Project	IEEE 802.16 Broadband Wireless Access Working Group < http://ieee802.org/16 >	
Title	LDPC coding for OFDMA PHY	
Date Submitted	2004-11-12	
Source(s)	Brian Classon Yufei Blankenship Motorola	brian.classon@motorola.com yufei.blankenship@motorola.com
	Jerry Kim Panyuh Joo Gyubum Kyung Hongsil Jeong Sang-Hyo Kim Hanju Kim DS Park Jaeho Jeon Samsung	kimjy@samsung.com panyuh@samsung.com gyubum.kyung@samsung.com hongsil.jeong@samsung.com sanghyo7.kim@samsung.com hanju.kim@samsung.com dspark@samsung.com jhjeon@samsung.com
	Eric Jacobsen Bo Xia Intel	eric.a.jacobsen@intel.com bo.xia@intel.com
	Kyuhyuk Chung Min-seok Oh LG Electronics	kyuhyuk@lge.com minoh@lge.com
	Brian Johnson Alek Purkovic Nina Burns Sergey Sukobok Nortel Networks	brjohnso@nortelnetworks.com apurkovi@nortelnetworks.com nburns@nortelnetworks.com ssukobok@nortelnetworks.com
	Eli Sasha Zion Hadad Yigal Leiba Itzik Kitroser Yossi Segal Oren Elkayam Runcom Technologies	shasha@runcom.co.il zionh@runcom.co.il yigall@runcom.co.il itzikk@runcom.co.il yossis@runcom.co.il Elkayam@runcom.co.il

Re: IEEE P802.16-REVe/D5-2004, sponsor ballot

Abstract This contribution contains additional text output from an informal LDPC group

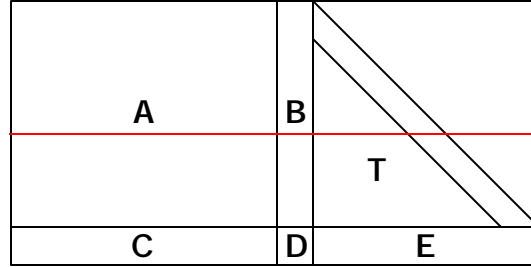
For efficient encoding of LDPC, \mathbf{H} are divided into the form

where \mathbf{A} is $(m-z) \times k$, \mathbf{B} is $(m-z) \times z$, \mathbf{T} is $(m-z) \times (m-z)$, \mathbf{C} is $z \times k$, \mathbf{D} is $z \times z$, and finally, \mathbf{E} is $z \times (m-z)$. $\begin{pmatrix} \mathbf{B} \\ \mathbf{D} \end{pmatrix}$ and \mathbf{D} correspond to the expanded \mathbf{h}_b and $\mathbf{h}_b(m_b - 1)$, respectively. The basic structure of the \mathbf{H} matrix is

Further, all these matrices are sparse and \mathbf{T} is lower triangular with ones along the diagonal. \mathbf{B} and \mathbf{D} part have the column degree 3 and \mathbf{D} has shift value of a (a is an integer, $0 \leq a \leq z-1$). \mathbf{B} is with the shift value a of the first entry and shift value 0 in the middle of the column. This other entry is non-zero.

Fig. 12 Block diagram of the encoder architecture for the block LDPC code.

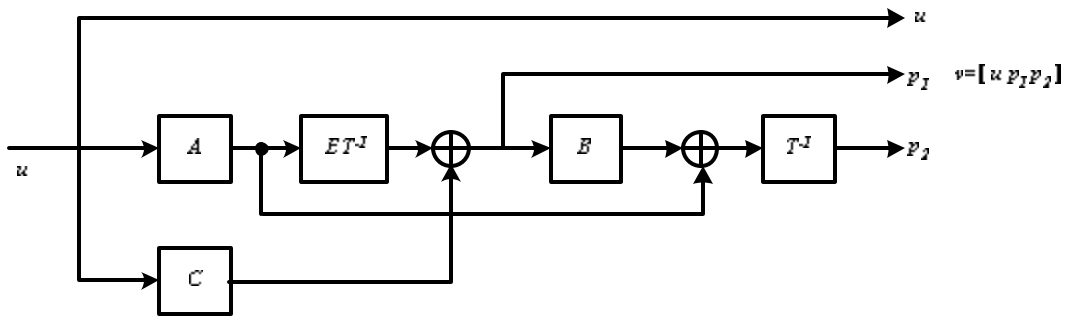
As a result, the encoding procedures and the corresponding operations can be summarized below and illustrated in Fig. 1.

Encoding procedure

Step 1) Compute $\mathbf{A}\mathbf{u}^T$ and $\mathbf{C}\mathbf{u}^T$.

Step 2) Compute $\mathbf{E}\mathbf{T}^{-1}(\mathbf{A}\mathbf{u}^T)$.

Step 3) Compute \mathbf{p}_1^T by $\mathbf{p}_1^T = \mathbf{E}\mathbf{T}^{-1}(\mathbf{A}\mathbf{u}^T) + \mathbf{C}\mathbf{u}^T$.

Step 4) Compute p_2^T by $Tp_2^T = Au^T + Bp_1^T$.
